Project	IEEE 802.16 Broadband Wireless Access Working Group < http://ieee802.org/16 >	
Title	Fixes for Network Entry Flow Charts	
Date Submitted	2006-11-16	
Source(s)	Nadav Lavi et al Alvarion Ltd. [Address Line 1] [Address Line 2]	Voice: +97236457834 Fax: [Fax Number] [mailto:Nadav.lavi@alvarion.com]
Re:		
Abstract	Fixes for Network Entry Flow Charts in 802.16e	
Purpose	For the review in 802.16 Maint TG	
Notice	This document has been prepared to assist IEEE 802.16. It is offered as a basis for discussion and is not binding on the contributing individual(s) or organization(s). The material in this document is subject to change in form and content after further study. The contributor(s) reserve(s) the right to add, amend or withdraw material contained herein.	
Release	The contributor grants a free, irrevocable license to the IEEE to incorporate material contained in this contribution, and any modifications thereof, in the creation of an IEEE Standards publication; to copyright in the IEEE's name any IEEE Standards publication even though it may include portions of this contribution; and at the IEEE's sole discretion to permit others to reproduce in whole or in part the resulting IEE

Figure 67-Handling SBC-REQ

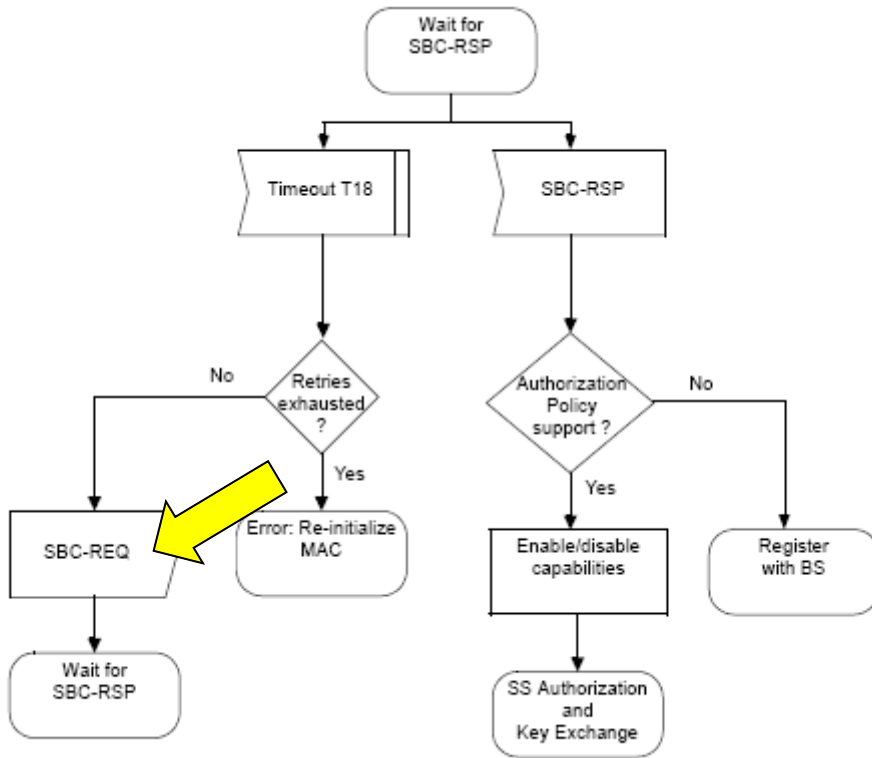
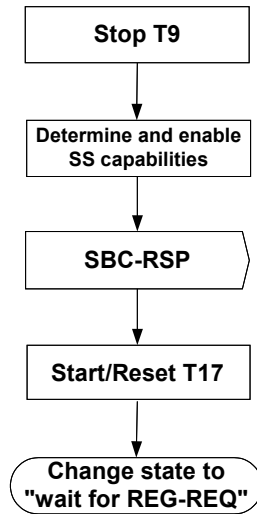
1. There is an unclear definition of how to handle expiration of T9 in the BS side in SBC transaction, and expiration of T17 in the BS side in REG transaction. The condition for “Release and age-out connections” is unclear and not well defined. In addition, this action is local to the BS and thus remains unknown to the SS. We suggest that the BS would send unsolicited RNG-RSP message with Abort instruction when these timers expire.
2. The current Network Entry flow chart cannot handle retransmission, either due to processing delays or message drop. After the BS transmits a response message, it will proceed directly to the next state in the Network Entry flow and thus cannot handle a retransmission of request by the SS; this would cause the Network Entry procedure to end in failure. For example, the following flow chart (Figure 67 in 802.16e-2005) shows that BS sends SBC-RSP.

Replace Figure 67 in 6.3.9.7 with the following figure:

Figure 70 – Handling REG-REQ

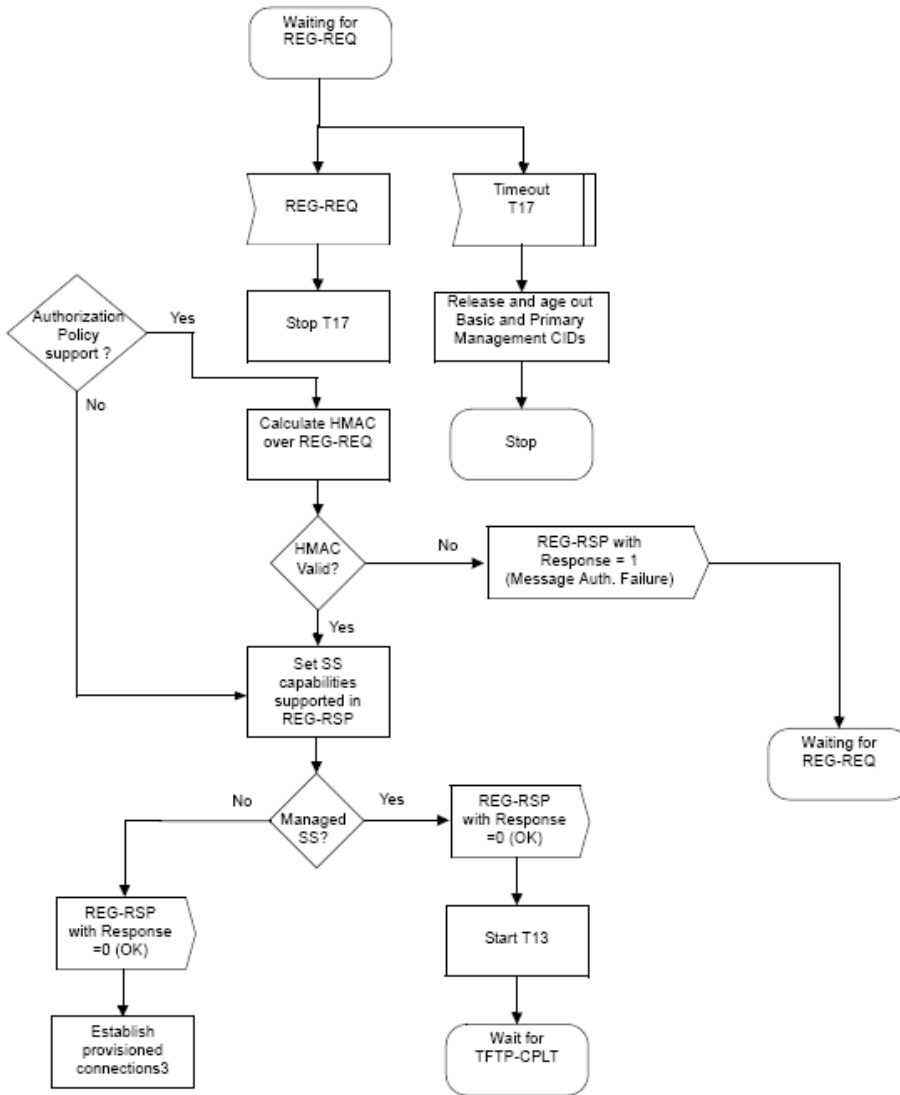
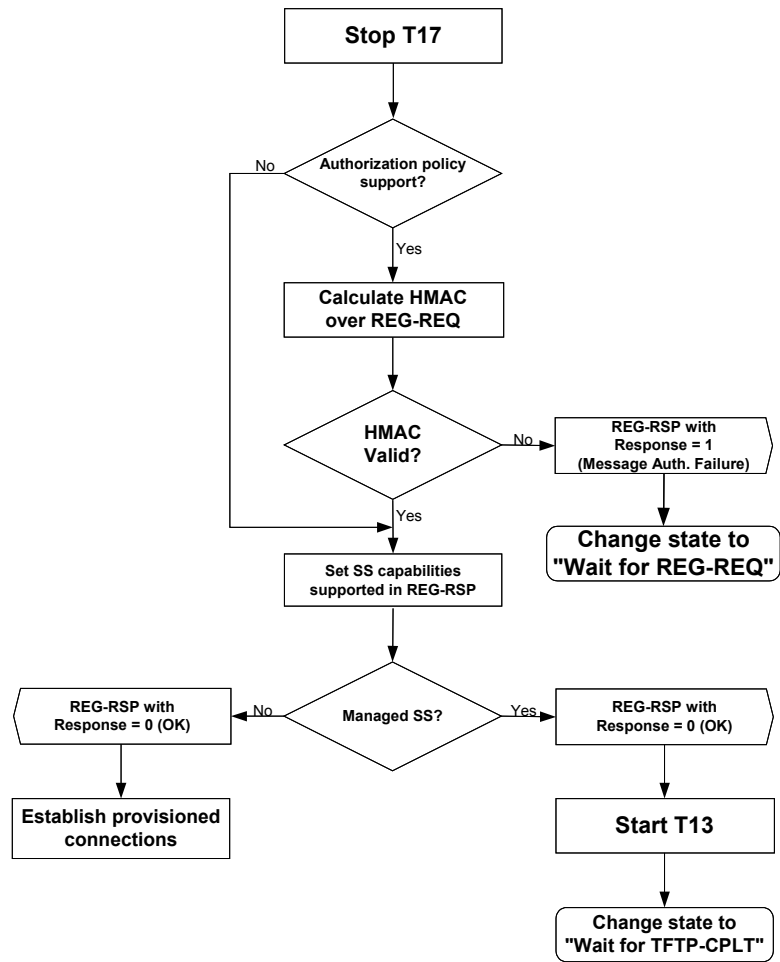
However after sending SBC-RSP, the BS proceeds directly to the registration step. The corresponding flow chart (Figure 70) does not contain any state where a retransmission of SBC-REQ can be received and processed. This is just an example of one single scenario. Similar failures can be identified for other steps in the entire Network Entry flow.

Replace Figure 70 in 6.3.9.9 with the following figure:

We suggest the Network Entry process be specified using 1) Network Entry state machine, and 2) set of actions/procedures of handling the Network Entry messages. This will provide a clearer definition of the network entry procedure as well as the handling of error/failure conditions.

Figure 68 – Registration – SS

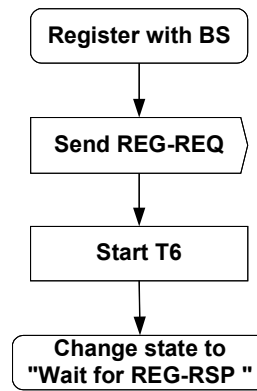
Replace Figure 68 in 6.3.9.9 with the following figure:

Figure 69 – Handling REG-RSP

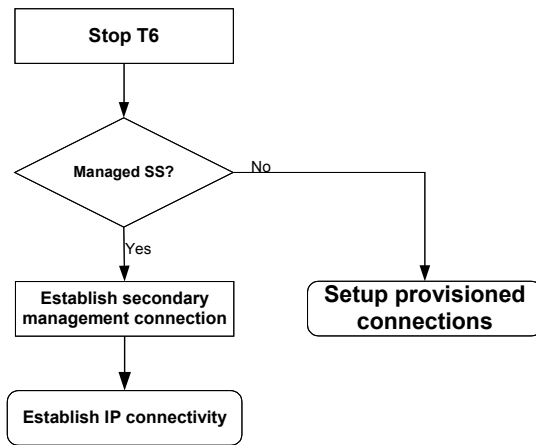
Replace Figure 69 in 6.3.9.9 with the following figure:

Figure 66 – Handling SBC-RSP

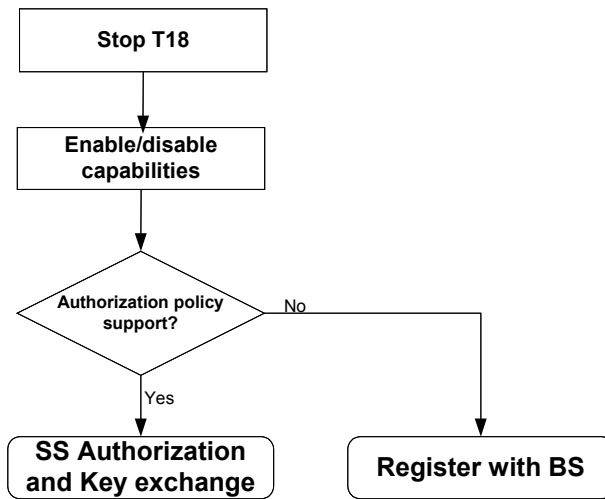
If the SS does not receive SBC-RSP within T18 timeout, it will retransmit the SBC-REQ (Figure 66).

Replace Figure 66 in 6.3.9.7 with the following figure:

Figure X – Network entry state-machine BS side (* Applies only to OFDMA)

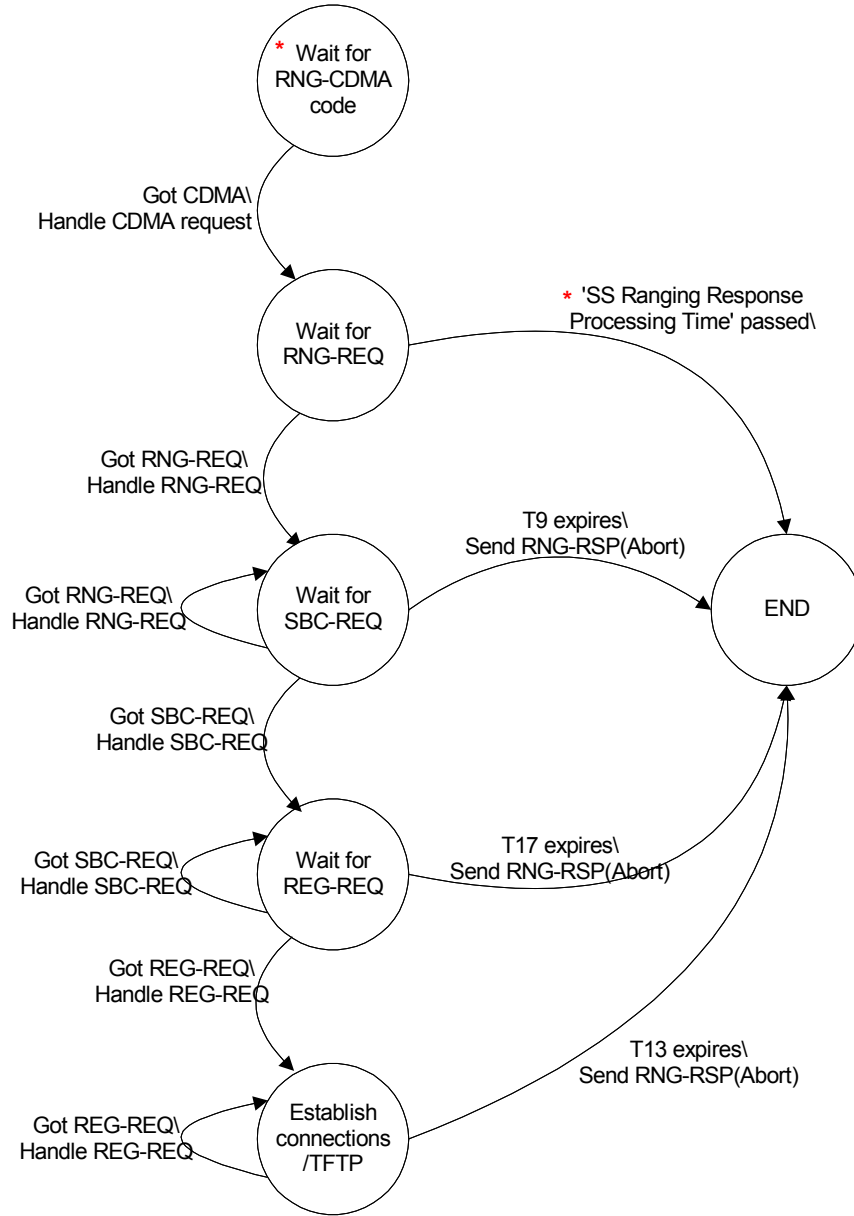
Add the following Figure:
